DRAFT SAFETY EVALUATION  
(CONTAINMENT SYSTEMS)  
GRAND GULF UNITS 1 & 2  
DOCKET NOS. 50-416 and 50-417

6.2 Containment Systems

FIGURE 2- CONTAINMENT PRESSURE ANALYSIS - MAIN STEAM LINE BREAK

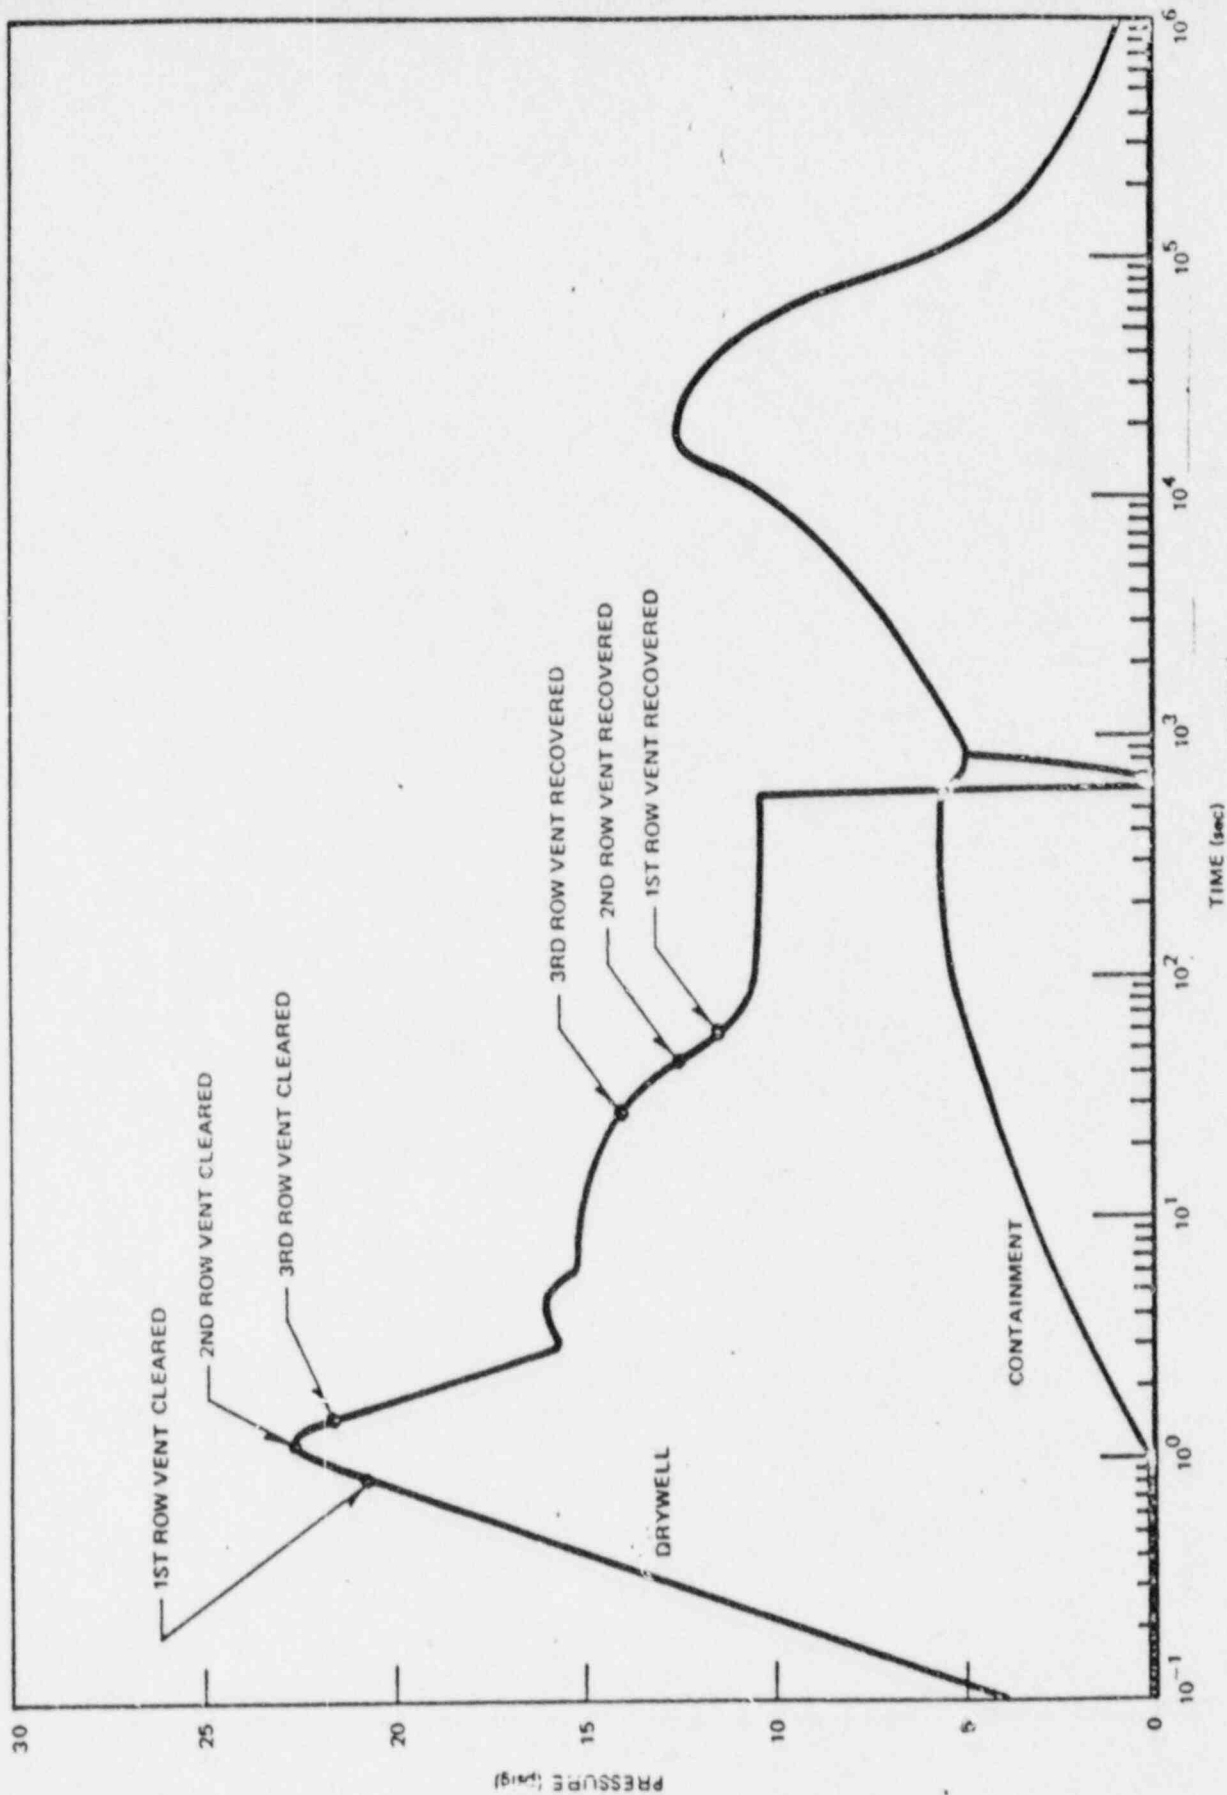
In the Grand Gulf containment analysis the applicant has assumed a level rise time of two seconds and based on this assumption has calculated that the peak drywell differential pressure would be 22.6 psid. (Figure 2). The applicant has also provided studies of level rise time as a function of operating conditions and the sensitivity of peak drywell differential to level rise time. These studies indicate that the most rapid level rise would be about one second assuming a hot standby condition and would

Based on these analytical models, the applicant has determined that the postulated rupture of a main steam line would result in the highest drywell differential pressure and has calculated this pressure to be 22.6 psid. The applicant has stated in the PSAR that the drywell will be designed for a pressure of 30 psid which provides a margin of 33% above the peak calculated value.

Both the Regulatory Staff and our consultants have reviewed the analytical methods employed in the drywell pressure response calculation. Based on our review and our consultants' recommendations we believe that this margin should be adequate to account for uncertainties in the GE vent clearing and vent flow models.
